5.0 DESIGN FEATURES

Proposed
Index Page XIV
and
Technical Specification 5.0
Pages 5-1 and 5-2

FIGURE B.1-1
DAVIS-BESSE NUCLEAR POWER STATION
EXCLUSION AREA

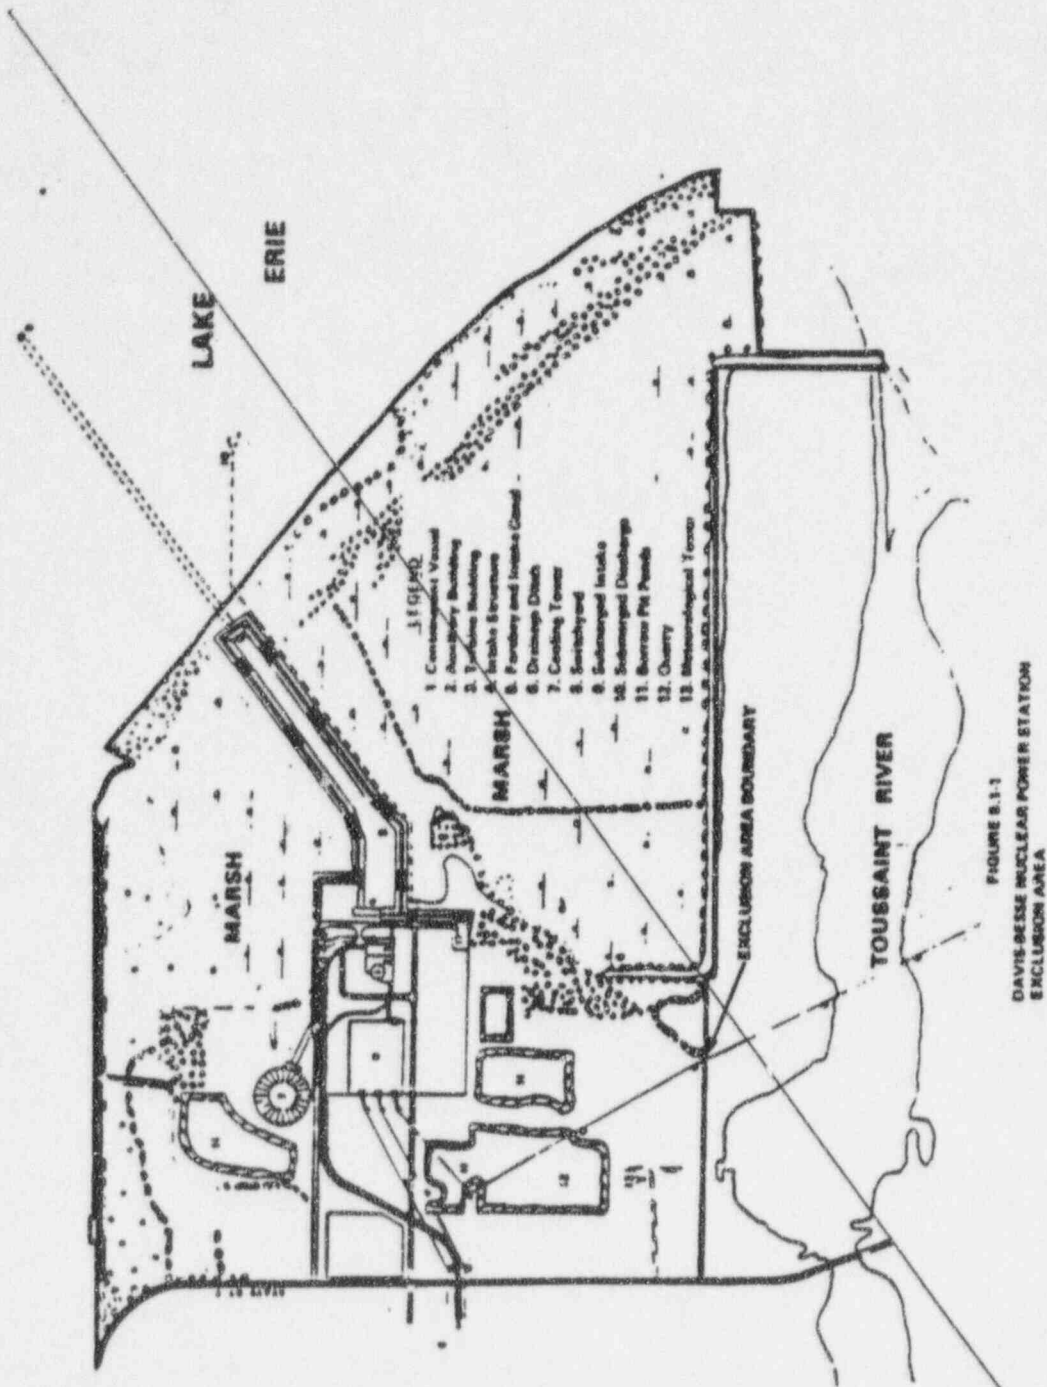
~~5.1.1 The exclusion area is shown on Figure 5.1-1.~~

deleted

DAVIS-BESSE NUCLEAR POWER STATION
LOW POPULATION ZONE
FIGURE 5.1-2

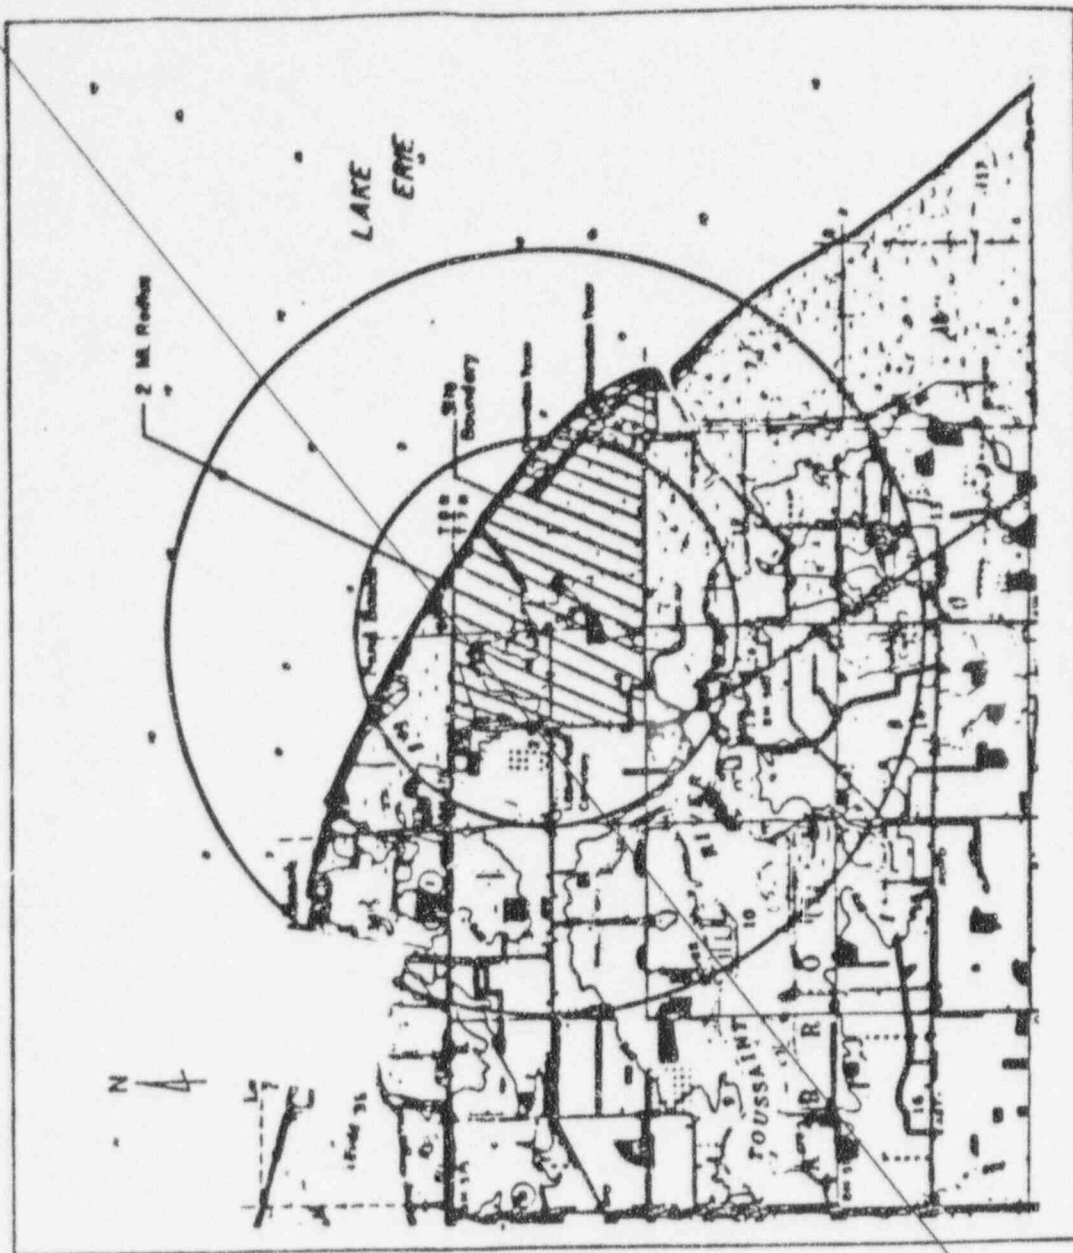
~~5.1.2 The low population zone is shown on Figure 5.1-2.~~

Deleted

DAVIS-BESSE NUCLEAR POWER STATION
UNRESTRICTED AREA
BOUNDARY FOR GASEOUS EFFLUENTS
Fig. 5.1-4

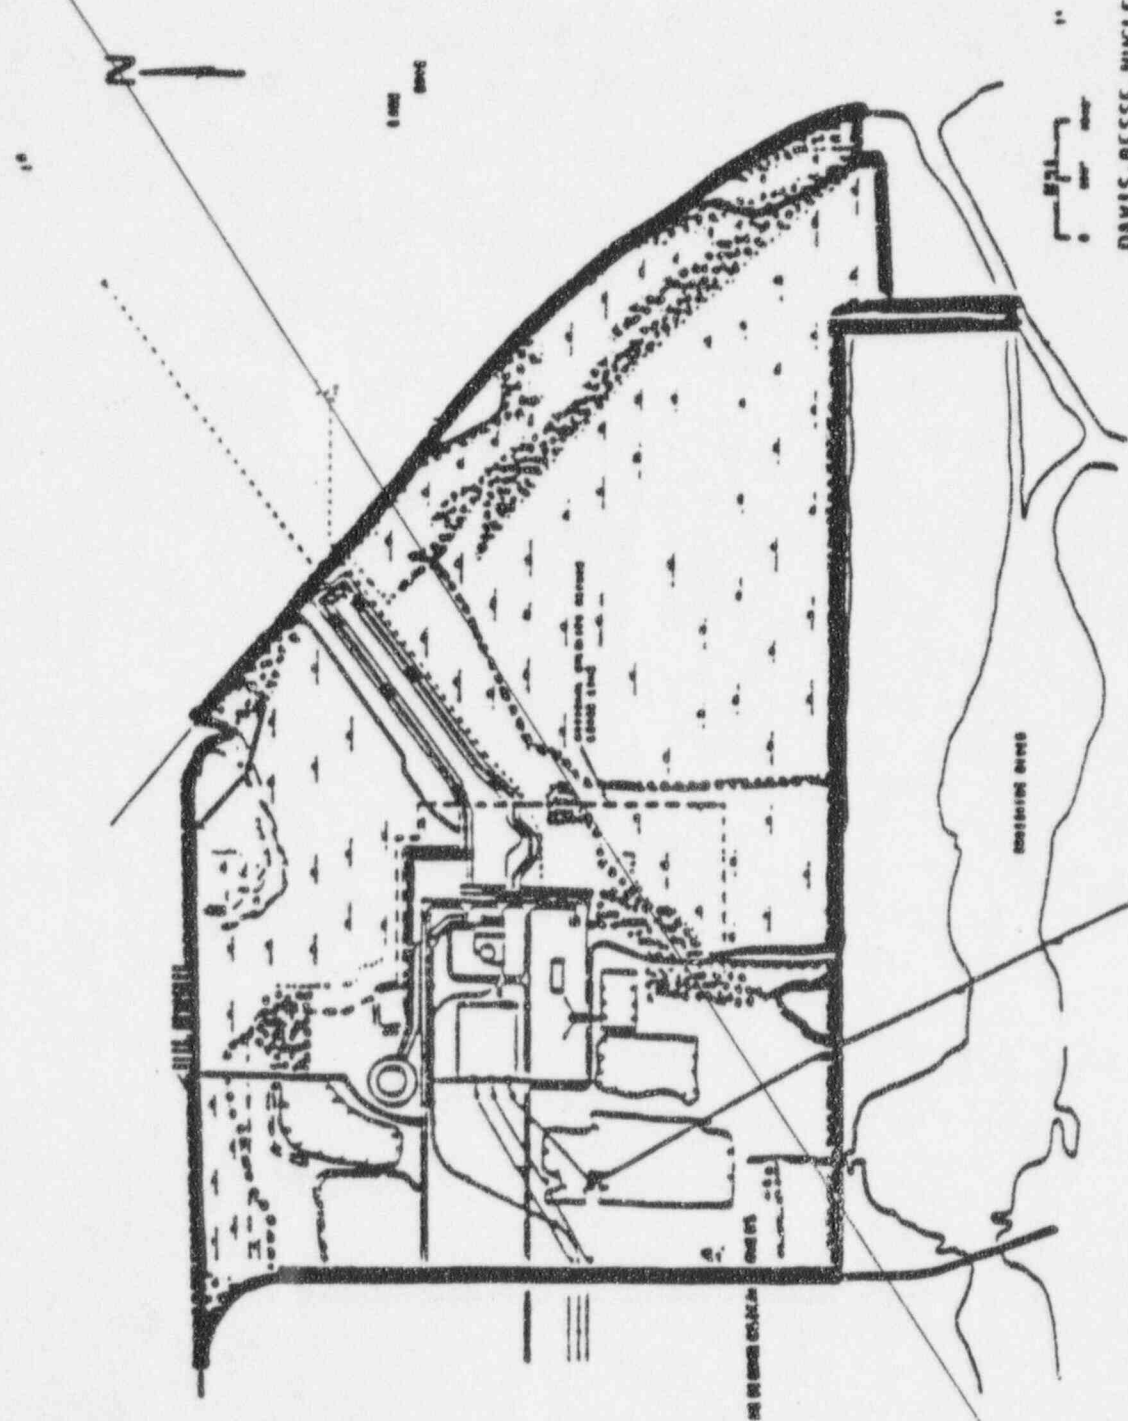
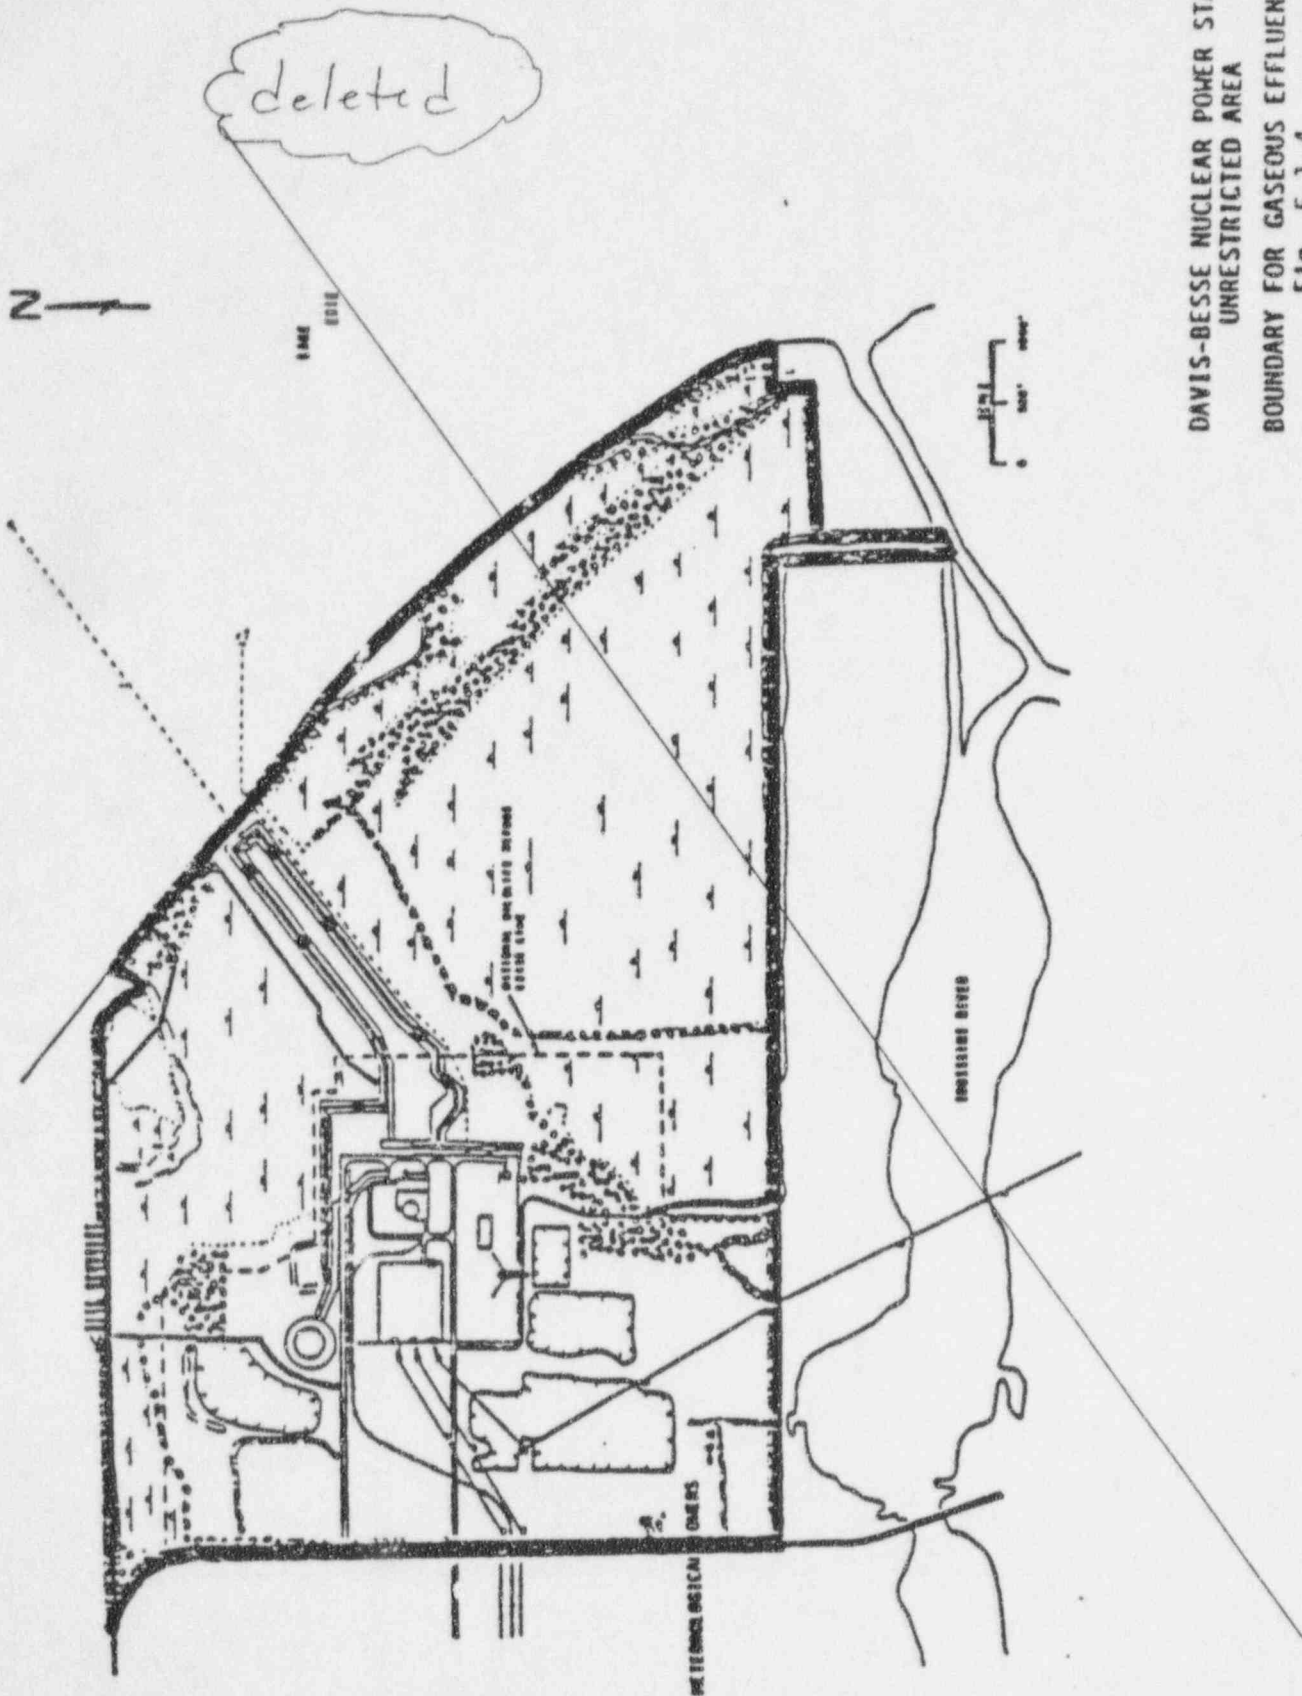
~~5.1.3 The UNRESTRICTED AREA and SITE BOUNDARY for radioactive liquid effluents is shown on Figure 5.1-3. The UNRESTRICTED AREA and SITE BOUNDARY for radioactive gaseous effluents is shown on Figure 5.1-4.~~

Deleted

deleted
